NAVIGATION - GPS-4000S GLOBAL POSITIONING SYSTEM SOFTWARE UPDATE

MTL-34-01
Page 1 of 3

**NO SUPPORT TO PERFORM LOCALIZER PERFORMANCE WITH VERTICAL (LPV)
AND REQUIRED NAVIGATION PERFORMANCE (RNP) LESS THAN 0.3 NAUTICAL
MILE APPROACHES OVER ALASKA**

NAVIGATION - GPS-4X00() - SOFTWARE UPDATE FOR UNIVERSAL TIME COORDINATED (UTC) TIME OFFSET AND GNSS POSITION NEAR 180 DEGREES WEST LONGITUDE (CONVERTS BLACK LABEL CPN 822-2189-100 TO BLACK LABEL CPN 822-2189-101)

Map
Figure 1

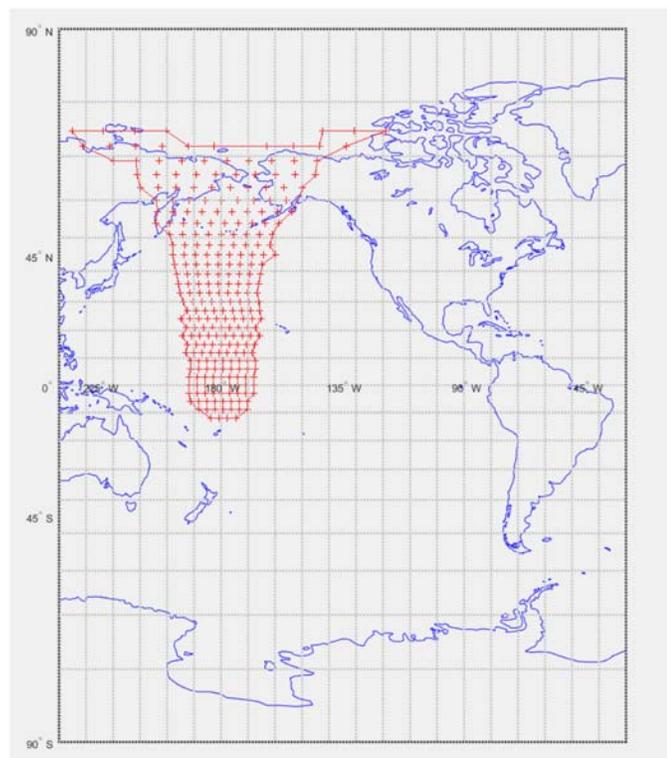
- (1) The Root Cause has been identified as an improper implementation in the computation of the longitude at which the GPS signal penetrates the ionosphere when the satellite is located across 180 degrees W Longitude.
- (2) The affected region is limited to the area within the solid red line boundary indicated in the attached map. The region extends 20 degrees on either side of 180 degrees W Longitude and extends from the Northern Hemisphere to 10 degrees Latitude in the Southern Hemisphere. Refer to Figure 1.

- (3) The potential reduction in position accuracy caused by the computational issue prevents the GPS-4000S, CPN 822-2189-100, from supporting LPV approaches at LPV-equipped airports in the affected region.
- (4) Un-announced, but bounded reduced positional accuracy in the affected region limits operations to RNP 0.3 NM, or higher (Positional error will be bounded to 0.3 NM but may not be bounded by the protection level (HPL) that is output by the GNSS).

- (1) A software update that corrects this issue is targeted to be available in Q1 2020.
- (2) Until that software update is available, operational limitations will need to be applied. The operational limits are:
 - (a) Do not use the GPS-4000S, CPN 822-2189-100, to perform LPV approaches at airports in Alaska listed below. There are no airports outside of Alaska that are in the affected region that support LPV approaches at the time of this SIL publication. LPV-equipped airports will be monitored on every database update and if additional LPV-equipped airports are identified, this SIL will be updated.
 - (b) Do not perform operations that require an accuracy better than RNP 0.3 NM (For example, 0.1, 0.11, 0.15, etc.) in the region identified in the above map (+/- 20 degrees of 180 degrees W Longitude) or at the airports in Alaska listed below.
